SERVICE BULLETIN

SUBJECT: FLIGHT CONTROL TRIM INDICATOR SYSTEMS (MOD N493)

S/B NMD-27-18
Page 1 of 7

Rework of Trim Indicator Drum Assemblies
Figure 1

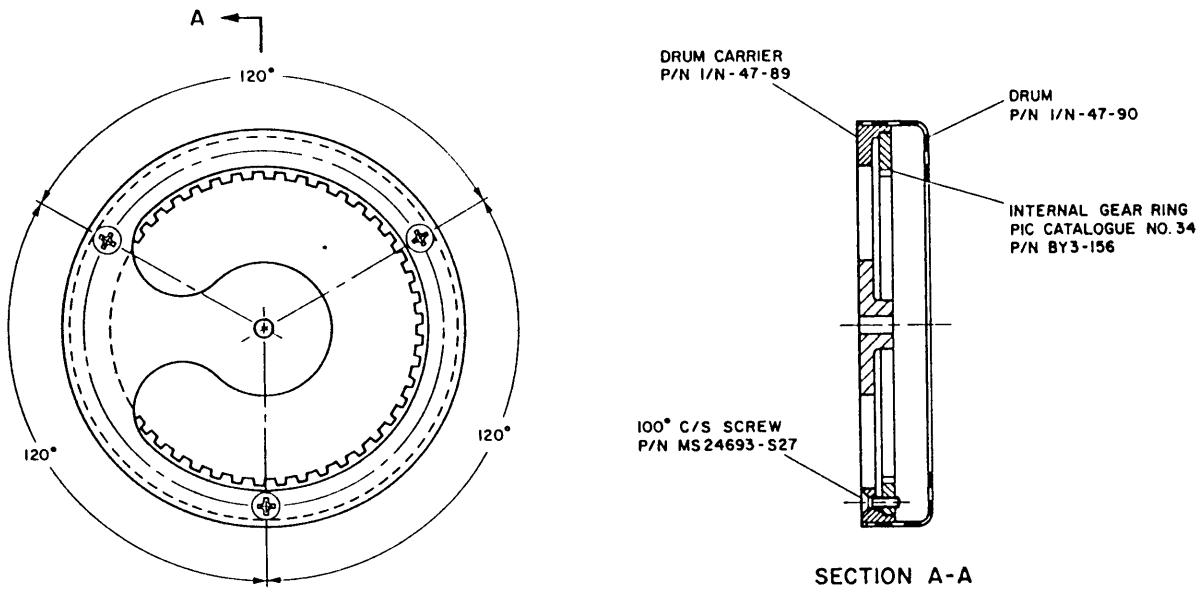
- F. Inspect the indicator drum assembly to ensure that the internal gear ring is correctly seated in the drum carrier (Ref Figure 1). If it is not correctly seated, press the gear ring back into the carrier drum until correctly seated taking care not to damage the drum or gear ring.

- G. Using a No.32 drill (0.1160 inches diameter, 2.95 mm), drill three holes equally spaced on a 1.875 inches pitch circle radius through the drum carrier and gear ring.

- H. Enlarge the three holes in the drum carrier only, to 0.142 inches diameter (3.6 mm) and countersink the enlarged holes 100 degrees and 0.280 inches diameter.
- J. Tap the three holes in the internal gear ring to 6-32 UNC and secure the gear ring to the drum carrier with three MS 24693-S27 screws or suitable alternative, using loctite AV or equivalent.

- (1) DRILL 3 HOLES (USING NO. 32 DRILL) EQUALLY SPACED AT 1.875 INCH PITCH CIRCLE RADIUS THROUGH DRUM CARRIER AND INTERNAL GEAR RING.
- (2) HOLES DIAMETER TO BE INCREASED TO 0.142 INCH (3.6 MM) IN DRUM CARRIER ONLY THEN COUNTERSINK ENLARGED HOLES 100° TO 0.280 INCH DIA.
- (3) TAP HOLES IN INTERNAL GEAR RING TO 6-32 UNF AND SECURE DRUM CARRIER TO GEAR RING AS DETAILED IN TEXT (REF PARA 2 H)

Rework of Trunnion Shaft
Figure 2

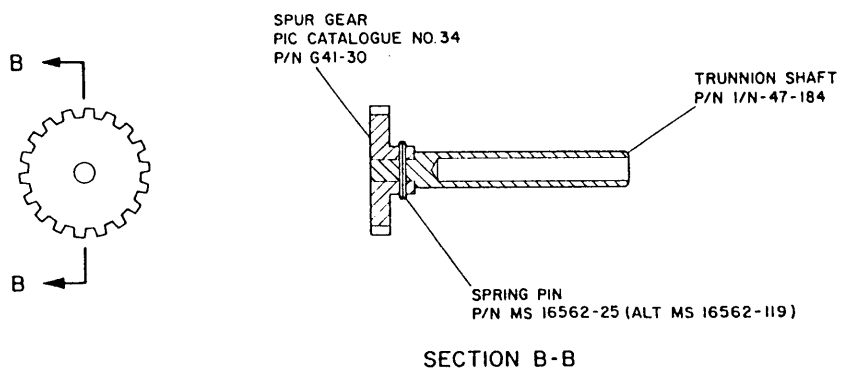
- K. Inspect the attachment of the spur gear to the trunnion shaft (Ref Figure 2 and IPC 27-40-01 Figure 1, items 10 and 7). If the attachment is by taper pin, the taper pin is to be removed and discarded.
- L. After taper pin has been removed, maintain the alignment of the hole through the gear and shaft, and enlarge the hole to between 0.094 and 0.097 inches diameter (2.4 to 2.5 mm) using appropriate sized drill and reamer.
- M. Fit spring pin P/N MS 16562-25 (alt MS 16562-119), using loctite AV or equivalent, through gear and trunnion shaft.

NOTE: The spur gear is made of stainless steel so the use of locquic T primer (alt. locquic N primer) is necessary before fitting the spring pin.
